ADDENDUM NO. 1 TO CONTRACT DOCUMENTS FOR THE BOLSA ROAD FISH PASSAGE IMPROVEMENTS PROJECT Project No. 26044004; Contract No. C0679

ATTACHMENT NO. 2: REVISED CONSTRUCTION PLAN SHEETS: G-02, C-04

REVISED CONSTRUCTION PLAN SHEETS: G-02, C-04

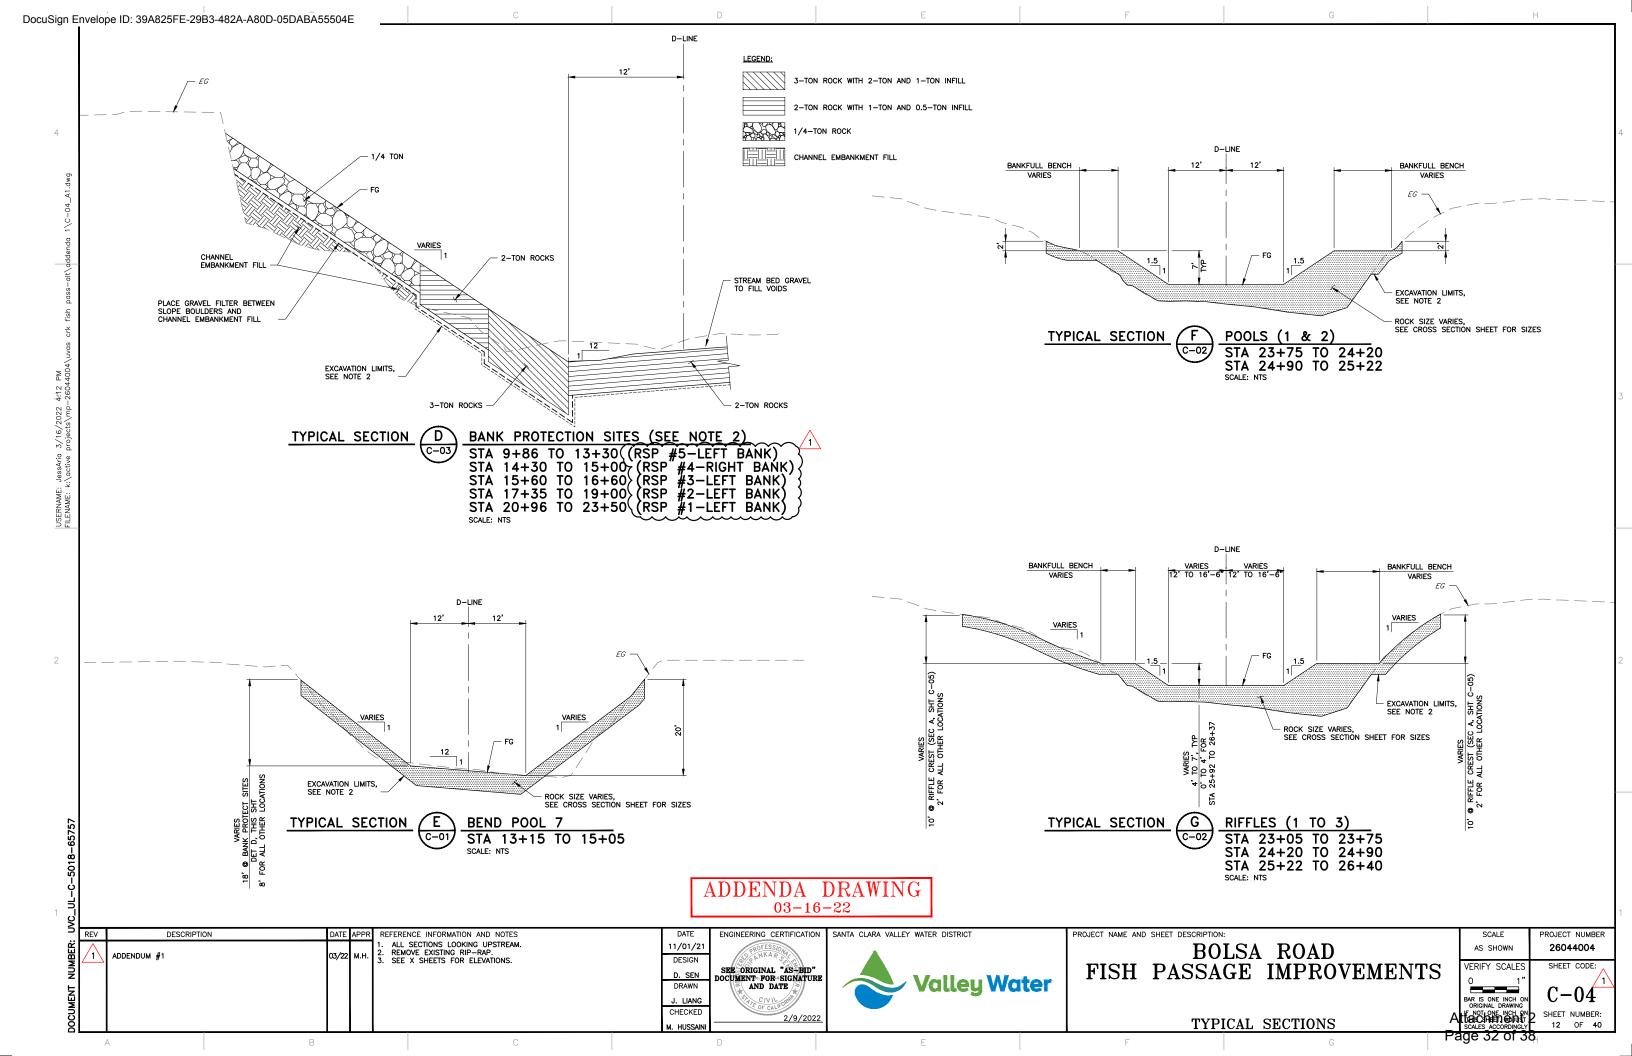
- 30. **<u>REPLACE</u>** the following plans with the sheets in Attachment No. 2:
 - a) G-02 (Sheet 2 of 40) SITE MAP, DRAWING INDEX, GENERAL NOTES AND DESIGN NOTES
 - b) C-04 (Sheet 12 of 40) TYPICAL SECTIONS
